Underbody NMC Criteria Update

Item 44g in Table 2-2 of TM 9-2320-387-10 says that if your up-armored HMMWV is missing a retainer plate or more than one screw, your truck is NMC. That hasn't changed, but TACOM LCMC will **add** inspection criteria for your M1151A1, M1152A1 and M1165A1 HMMWV's underbody armor. This is because it has a unique attaching scheme.

DON'T FORGET THE FOLLOWING UNDERBODY ARMOR CHECKS WHEN DOING YOUR PMCS!

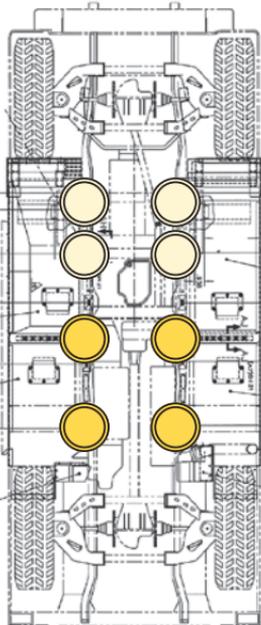
1. One of two plates must remain on each of the group of two front underbody panels.
2. One of two plates must remain on each of the group of two rear underbody panels.
3. A total of up to four retainer plates may be missing provided that the conditions above are met.

Front underbody panel plates and screws

Rear underbody panel plates and screws
